139 George Street, Avalon

Geotechnical Comments for Section 4.55

Geotechnical Comments in Regards to Updated Plans

GEOTECHNICAL INVESTIGATION:

Photo 5

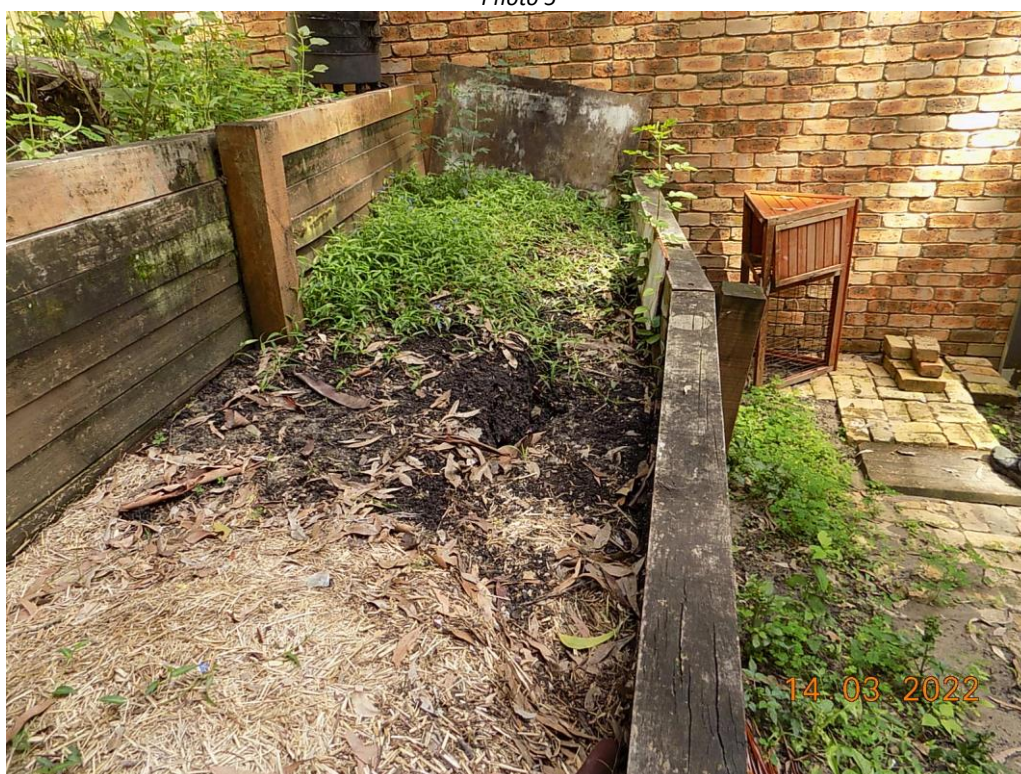
The timber retaining wall on the E side of the property is in the slow process of collapse (Photos 5 & 6). We recommend consideration be made to repairing/replacing the retaining wall during the proposed works. Alternatively, the retaining wall can to be inspected by the owners on an annual basis or after heavy prolonged rainfall, whichever occurs first, keeping a photographic record of the inspections. We can carry out these inspections upon request. Should any new movement be observed, the retaining walls are to be remediated or rebuilt to current engineering standards.

SITE PLAN – showing test locations and minimum extent of exploration pits / underpinning

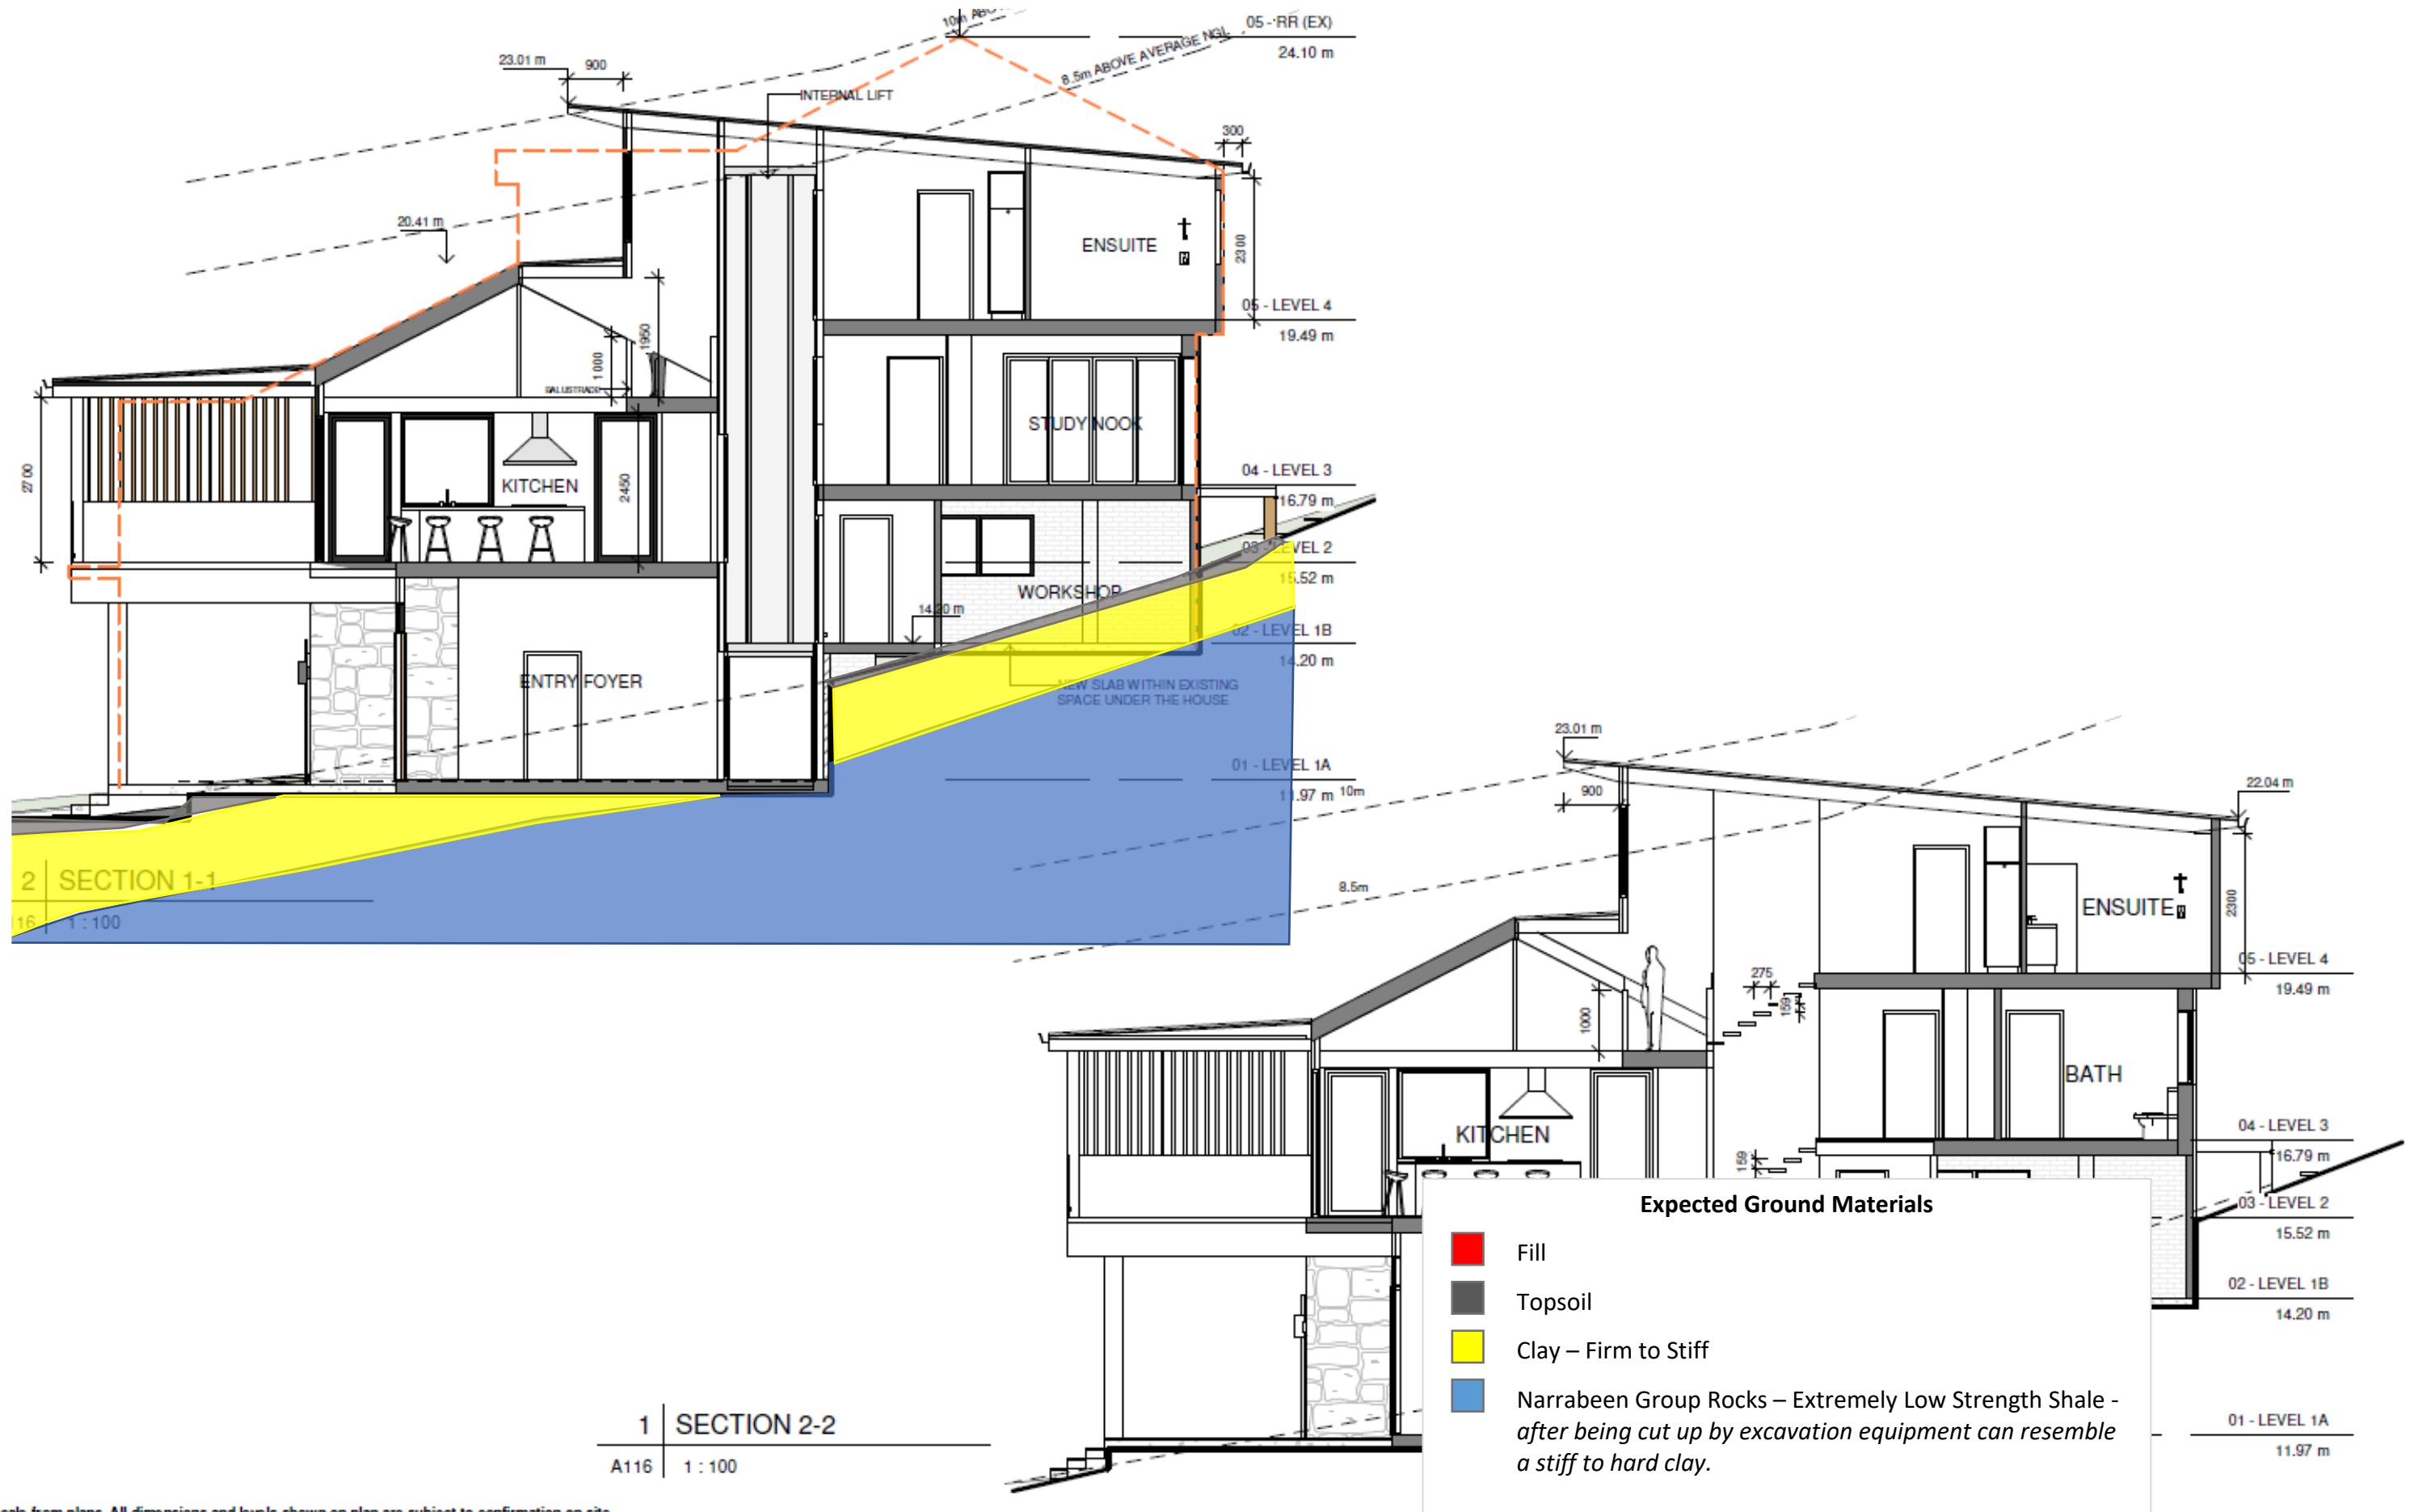
If the foundations are confirmed to extend below the zone of influence of the proposed excavation, the excavation may commence. If they are not, the walls will need to be underpinned to below the zone of influence of the cut prior to the excavation commencing. See the site plan attached for the minimum extent of the required exploration pits/underpinning.
